VILLAGE OF DOWNERS GROVE
Report for the Village
1/12/2021

SUBJECT:	SUBMITTED BY:
Belmont Bible Church, 5416, 5418, 5430 Belmont Road, and 2097 Inverness Avenue – Annexation, Zoning Ordinance Map Amendment and Special Use	Stan Popovich, AICP Director of Community Development

VILLAGE OF DOWNERS GROVE
REPORT FOR THE PLAN COMMISSION
DECEMBER 7, 2020 AGENDA

SUBJECT:	TYPE:	SUBMITTED BY:
20-PLC-0014 Belmont Bible Church	Annexation, Zoning Map Amendment, and Special Use	Gabriella Baldassari Development Planner

Concept 1

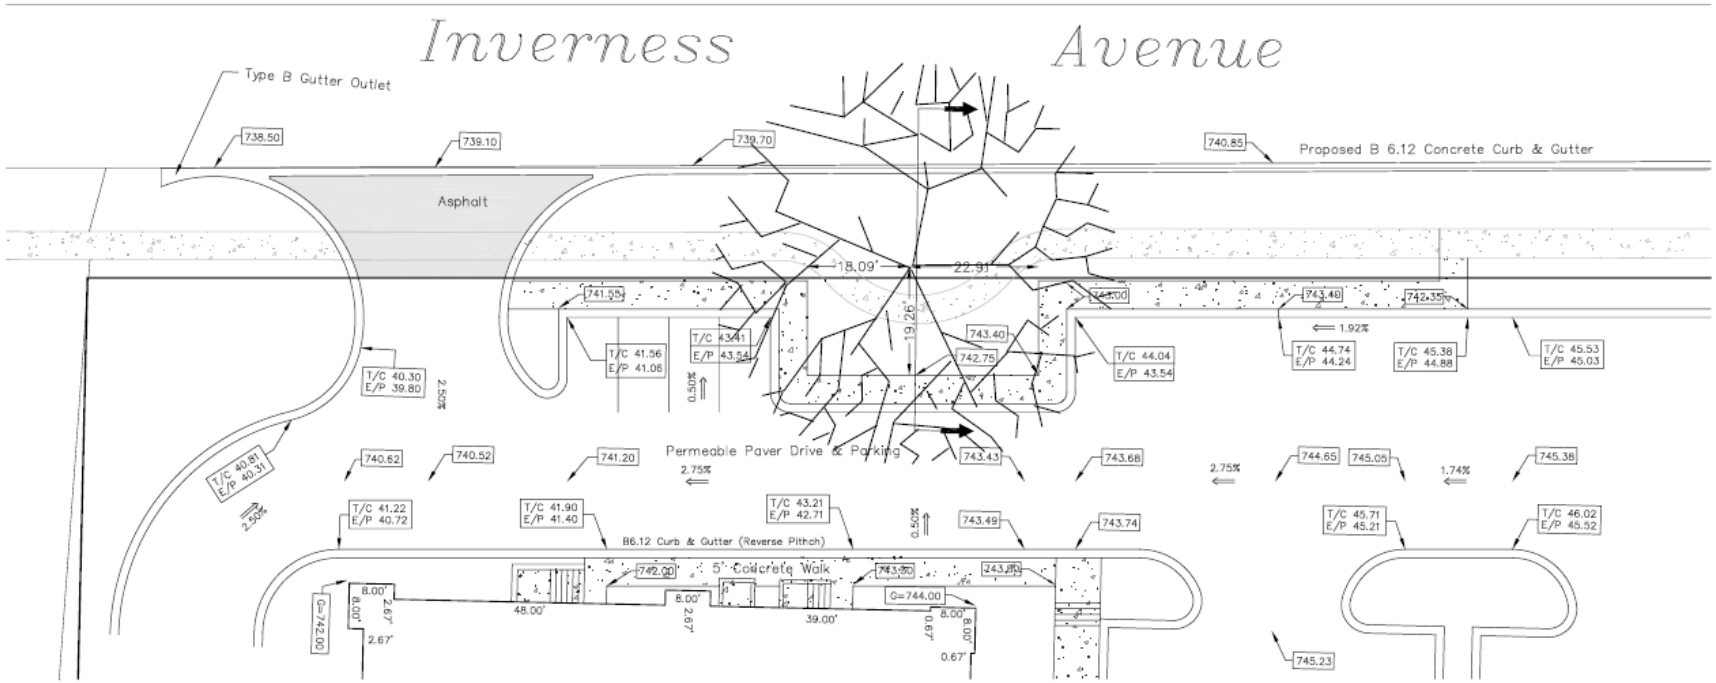
- Concept 1 - This concept relocates the sidewalk south of the tree, while maintaining the 24 foot wide parking lot drive aisle to allow full circulation around the building. Five parking spaces would be lost.

The petitioner prefers to remove the tree and construct the project as shown on the original site plan. The petitioner will be required to plant 12 new parkway trees, with an initial 2.5 inch caliper, and pay approximately $4,000 for the cost of the existing tree, per Village Code.

Concept 2

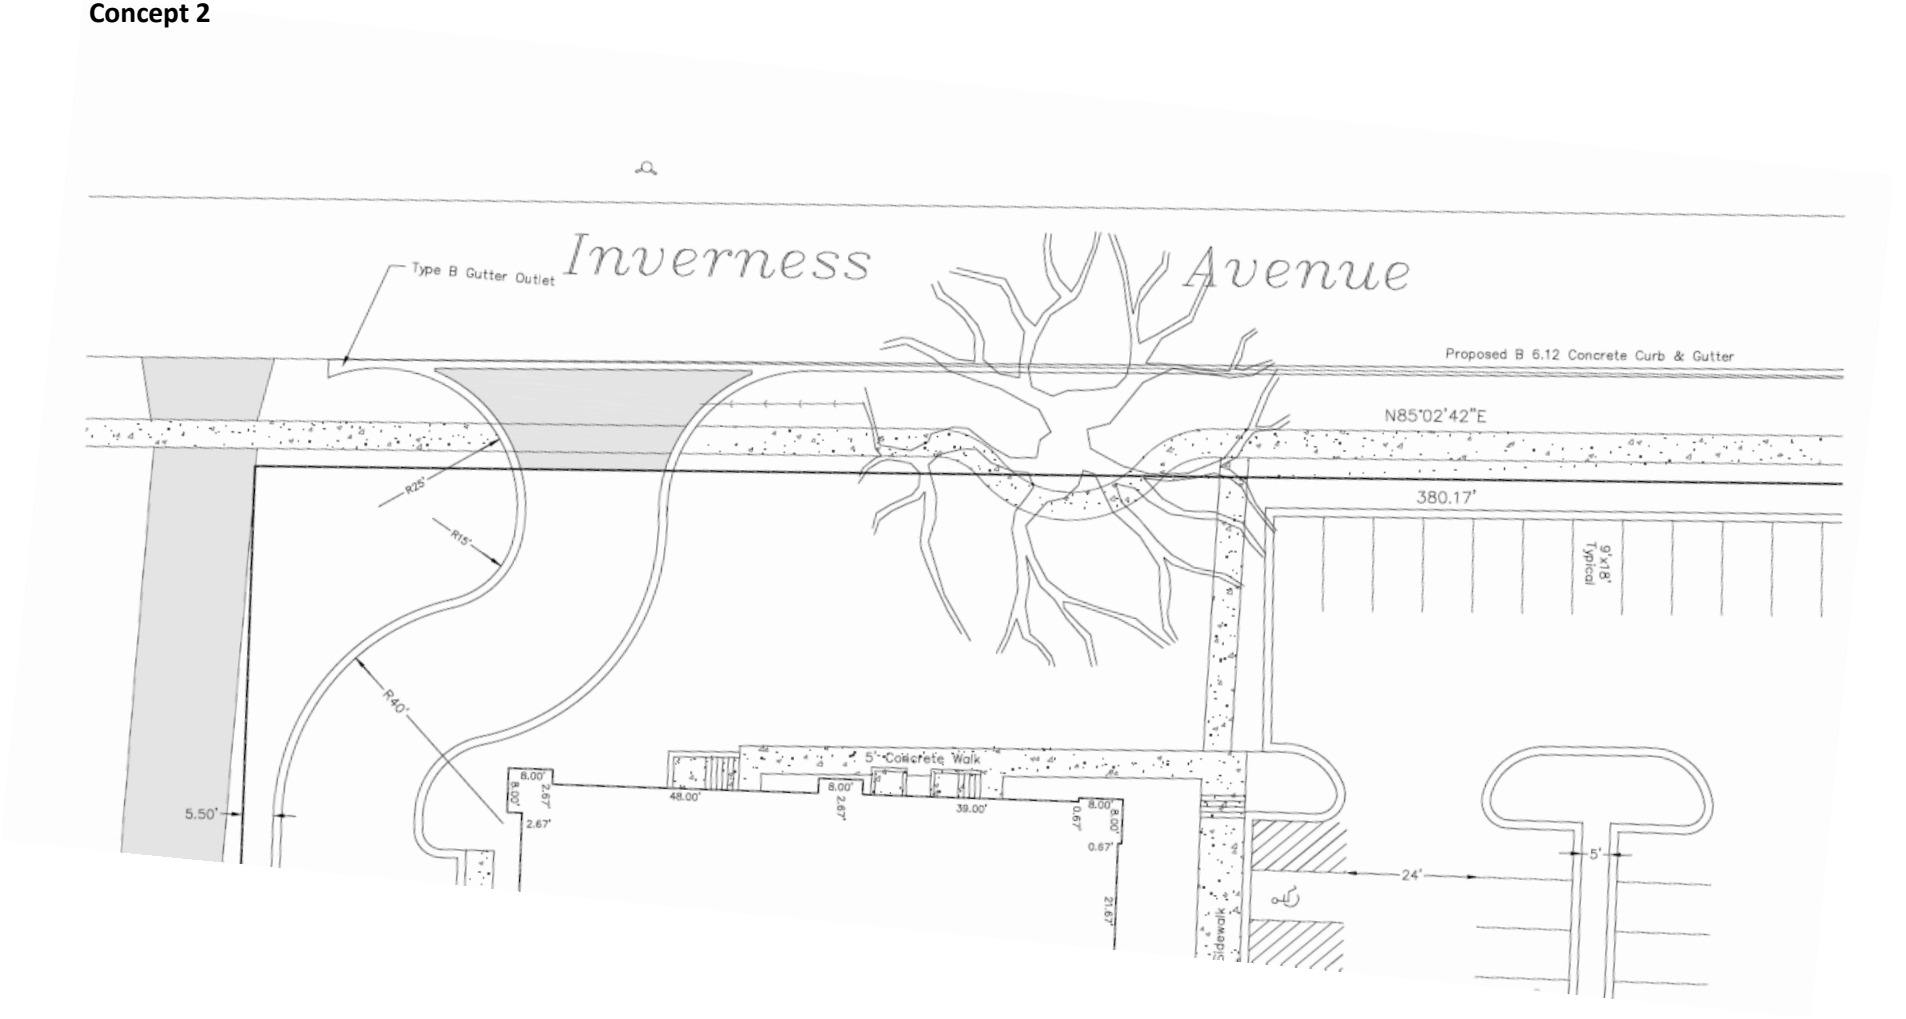
- Concept 2 - This concept removes the 24 foot drive aisle and all parking spaces north of the building. This will result in a loss of nine parking spaces and full circulation around the building will not be maintained.
